**Riverside County Transportation Commission (RCTC)  
ADA Transition Plan – Third Year Update  
June 2025**

# ADA Transition Plan –Updates - June 2025

Facility	All RCTC Facilities	Date	June 2025
Contact Person	ADA Coordinator, David Knudsen, RCTC	Address	4080 Lemon Street, Third Floor, P. O. Box 12008, Riverside, CA 92502-2208
Email	dknudsen@rctc.org	Phone	(951) 787-7141

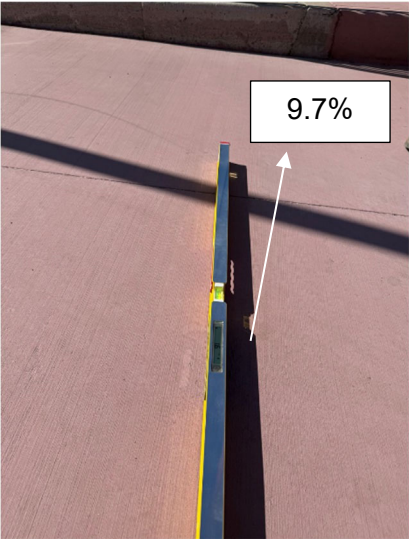
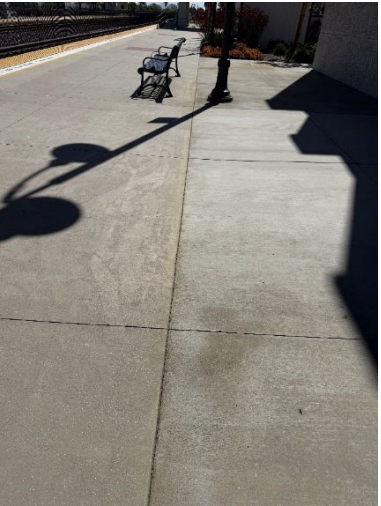
1. Pedestrian Entry	The slope of the sidewalk at the pedestrian entry is measured at 9.6% which makes it an inaccessible route.	<div>a. Provide an alternate accessible pedestrian entry route including five feet wide concrete sidewalk and marked road crossings</div> <div>b. Provide signage for the designated accessible route.</div>	An alternate route through the parking area is possible and should be considered.	<div>A. Complete</div> <div>An accessible path was constructed from the street to the parking lot. Measurements were taken and were compliant to ADA standards.</div> <div></div> <div>B. In Progress</div>

2. Curb ramp 1b	Flared side exceeds 1:10 slope (11.6%)	Repair flared sides of curb ramps to comply with 1:10 slope requirement or replace entire curb ramp. This will include placement of DWS.	<div>When repairs begin, use proper and precise instruments (4-foot smart level and 2-foot smart level) to fit within the curb ramp width, and the adjacent gutter to measure ramp slopes, cross slopes, and counter slopes.</div> <div>Use smart level instruments, calibrated in accordance with manufacturer's instructions before taking measurements.</div>	<div>Complete</div> <div>The curb ramp was reconstructed to be ADA standard.</div>

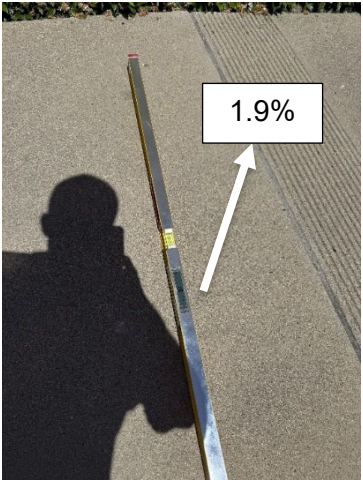
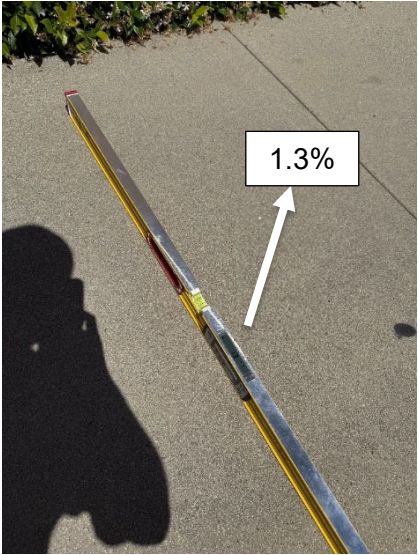
Facility/Area	Access Issue	Solution	Comments	Resolution Status
West Corona Station			See Attachment 6A for curb ramp locations, images of barriers, recommendations, and ADA requirements.	
				<div></div>
3. Curb ramp 2a	Sloped portion of ramp takes up the entire sidewalk in front of the main entrance.	Provide signage for the accessible route along the sidewalk leading to level walking route under the canopy	The landing for the curb ramp is under the station canopy is compliant. So, no structural changes are needed to this curb ramp or landing.	<div><p>Complete</p><p>This slope portion of the ramp was reconstructed to meet ADA standards. Signage is no longer required.</p></div>
4. Curb ramp 2b	Gutter slope exceeds 1:20 (9.1%). Flared side exceeds 1:10	Remove and replace flared sides of the curb ramp, portions of the	See comment for item 2.	<div><p>In Progress</p></div>

Facility/Area	Access Issue	Solution	Comments	Resolution Status
West Corona Station			See Attachment 6A for curb ramp locations, images of barriers, recommendations, and ADA requirements.	
	slope (12.2%). uneven level changes and trip hazard.	gutter to make slopes compliant Replace entire curb ramp. Repair uneven level changes and trip hazards. This will include placement of DWS.		 
5. Curb ramp 3b	Gutter slope exceeds 1:20 (9.1%). There are uneven level changes and trip hazards.	Remove and replace portions of the gutter to make slopes compliant Replace entire curb ramp. Repair uneven level changes and trip hazards. This will include placement of DWS.	See comment for item 2.	Complete  The area has been reconstructed to meet ADA standard.

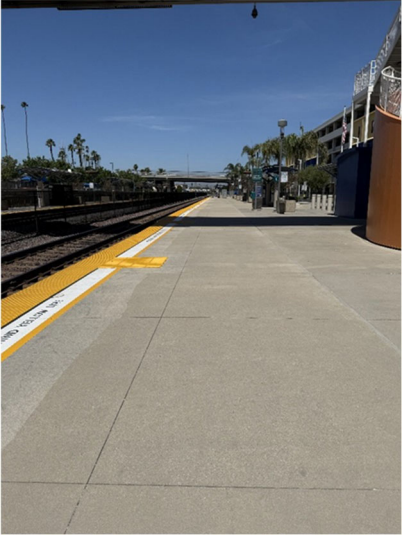
Facility/Area	Access Issue	Solution	Comments	Resolution Status
West Corona Station			See Attachment 6A for curb ramp locations, images of barriers, recommendations, and ADA requirements.	
				<div></div>
6. Curb ramp 4a	Trip hazard at DWS	Repair uneven level changes and trip hazards. Remove and reapply DWS. Provide beveled transition at DWS and adjacent concrete as required		<div><p>Complete</p><p>The curb ramp has been reconstructed with DWS to ADA standards.</p></div>

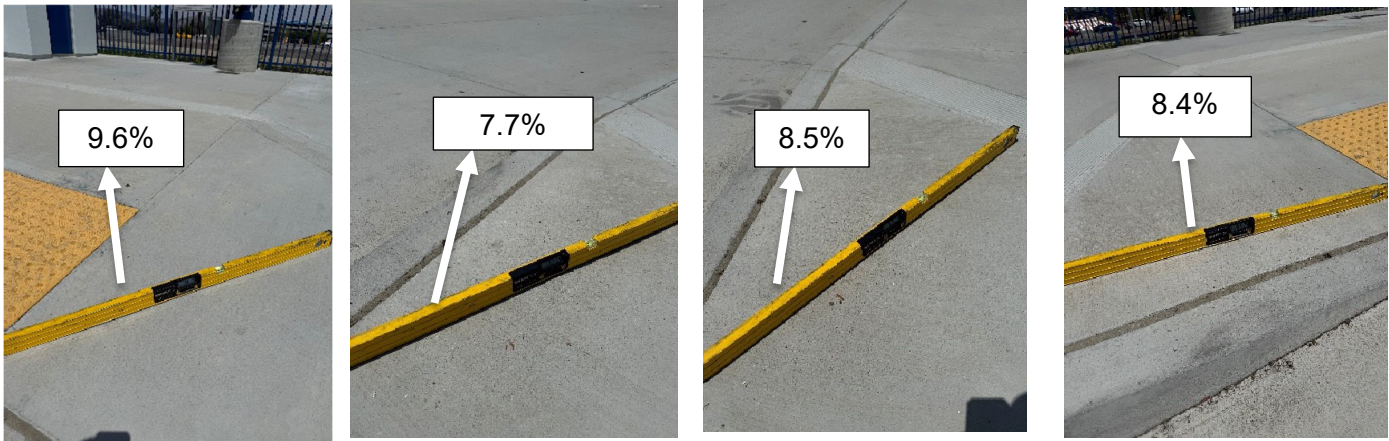
7. Pedestrian road crossing 3a-3b	Multiple cracks and gaps in excess of ½” wide and ¼” deep.	Repair cracks, gaps, uneven level changes and trip hazards within the marked pedestrian crossing. Every joint deeper than ¼” and wider than ½” shall be filled with concrete and crack fillers as required.		<div>Complete</div> <div>The walkway has been reconstructed to meet ADA standards.</div> <div></div>

8. General Accessible Paths	There are uneven joints and cracks observed in the concrete on the platforms and along accessible route. Sealant/filler in some deep joints is missing.	<div>Repair cracks, gaps, uneven level changes and trip hazards within the accessible route.</div> <div>Every joint deeper than ¼” and wider than ½” shall be filled with concrete and crack fillers as required.</div> <div>Every level change along the accessible route greater than ¼” and less than ½” height needs to be beveled (1:2 slope) or repaired using</div>	Create a maintenance plan for ongoing routine inspections and repairs of all components of the accessible route.	<div>Complete</div> <div>Repairs were conducted on the general access path to meet ADA standards.</div> <div></div>

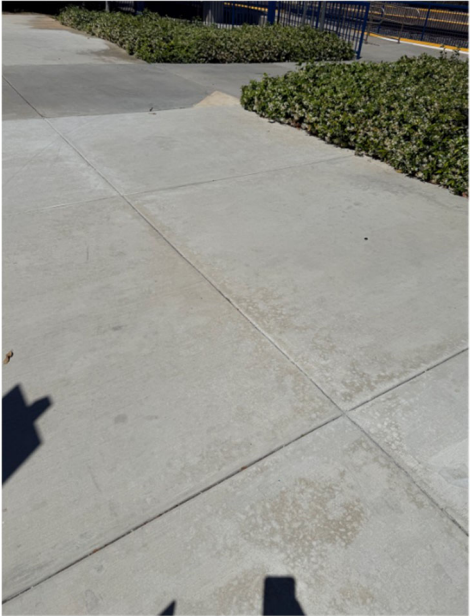
22. Curb ramp 4a	Cross slope of the ramp exceeds 2 %	Repair cross slope or replace entire curb ramp. This will include placement of DWS.	<p>When repairs begin, use proper and precise instruments (4-foot smart level and 2-foot smart level) to fit within the curb ramp width, and the adjacent gutters to measure ramp slopes, cross slopes, and counter slopes.</p> <p>Use smart level instruments, calibrated in</p>	Complete

Facility/Area	Access Issue	Solution	Comments	Resolution Status
North Main Corona Station			See Attachment 6B for curb ramp locations, images of barriers, recommendations, and ADA requirements.	
			accordance with manufacturer's instructions before taking measurements.	<p>Cross slopes were re-examined and were found to meet ADA standards. Measurements were at 1.9%, which is less than the 2% maximum standard.</p> <div></div>

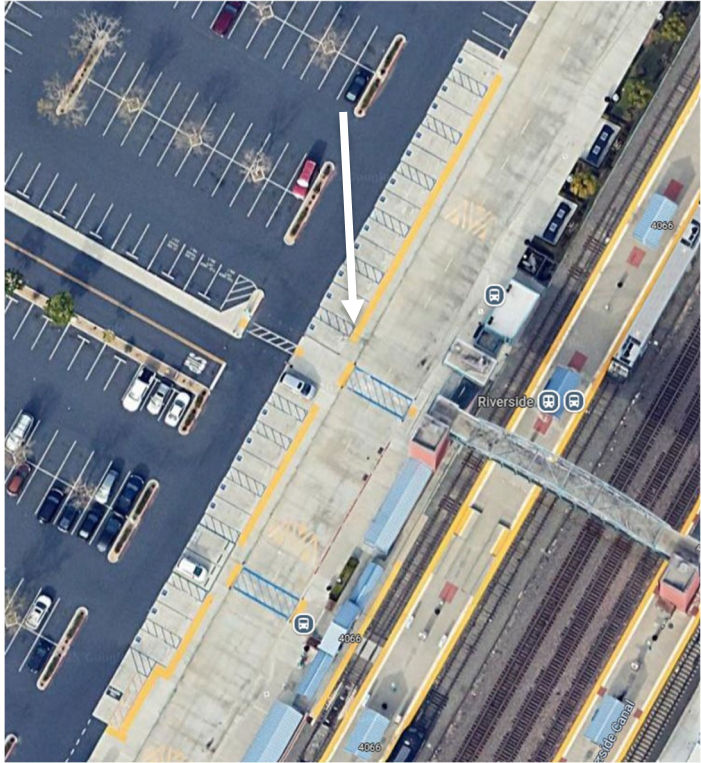
25.Pedestrian road crossing 1a-1b and 1a-5c	Signage identifying 1a-1b as the accessible route is missing.	Provide sign identifying 1a, 1b as the accessible route.		In Progress

Facility/Area	Access Issue	Solution	Comments	Resolution Status
North Main Corona Station			See Attachment 6B for curb ramp locations, images of barriers, recommendations, and ADA requirements.	
	Crossing from 1a to 5c is not on the accessible route and is marked.	Remove markings from inaccessible route

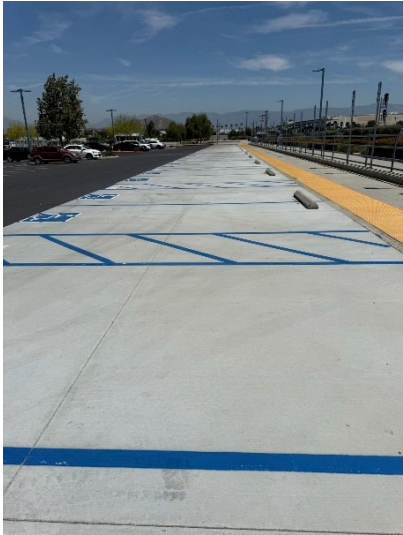
51.General Accessible Paths	There are uneven joints and cracks observed in concrete along the accessible route, and sealant/filler in deep joints is missing.	Examine and repair accessible routes where there are uneven joints and cracks observed in concrete along the accessible route, and where sealant/filler in deep joints is missing.	Create a maintenance plan for ongoing routine inspections and repairs of all components of the accessible route.	<p>i. Complete – Accessible routes uneven joints and cracks</p> <p>Accessible paths have been repaired to meet ADA standards.</p>

Facility/Area	Access Issue	Solution	Comments	Resolution Status
Riverside Downtown Station			See Attachment 6D for curb ramp locations, images of barriers, recommendations, and ADA requirements.	
		<p>Every joint deeper than ¼” and wider than ½” shall be filled with concrete and crack fillers as required.</p> <p>Every level change along the accessible route greater than ¼” and less than ½” height needs to be beveled (1:2 slope) or repaired using grinding tools and/or levelling compounds.</p> <p>Every level change greater than ½” needs to have a ramped surface (1:12) slope .</p>		<div></div> <p>ii. In Progress – Space around utility cover</p> <p>iii/iv. Complete – ADA accessible route cross slope of ramp. ADA access is accessible, cross slope confirmed to be ADA compliant.</p> <div></div>
